MEMORANDUM TO: Oconee Docket Files (50-269, 50-270, and 50-287)

SUBJECT: PRELIMINARY RESPONSES TO OPEN ITEMS AND CONFIRMATORY ITEMS FOR SAFETY EVALUATION REPORT ON THE DUKE ENERGY CORPORATION (DUKE) LICENSE RENEWAL APPLICATION FOR OCONEE NUCLEAR STATION UNITS 1, 2, AND 3.

FIGURES FOR RESPONSE TO SER OPEN ITEM 4.2.3-2

**FIGURE 1**  
**Illustrative Transient**

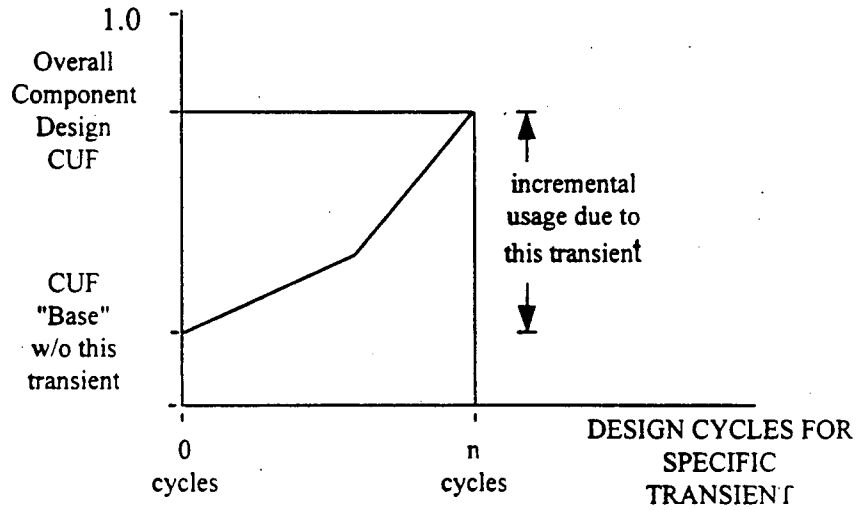
On the basis of the preceding discussion, the staff concludes that the applicant's TLAA of the RCS is not adequate to address the fatigue concerns for operation beyond the current design life of 40 years. The applicant must either develop an aging management program that incorporates a plant-specific resolution of GSI-190 or submit a technical rationale which demonstrates that the CLB will be maintained until some later point in time in the period of extended operation, at which point one or more reasonable options would be available to adequately manage the effects of aging. If GSI-190 is resolved prior to the period of extended operation, the applicant may follow the resolution of the GSI.

Figure 1 shows an illustrative transient where two stress range pairs are included in the transient of interest, giving a bi-linear relation between the number of cycles and usage factor. When pieced together the usage factor value at a given number of cycles is determined. Also it should be noted that the cumulative usage factor base for this transient is not zero. The base is the sum of the usage factors for all other transients. Each individual transient thus contributes to the overall cumulative usage factor through its own set of piecewise rates. In Figure 1, by including the usage factor value for this transient with all others, the overall component design cumulative usage factor is determined. (For convenience, the transient of interest is shown as the last in the sum producing the CUF. This is an allowed technique since no modification is being made at this time to any stress range magnitudes or postulated occurrences, hence there is no order dependency.)
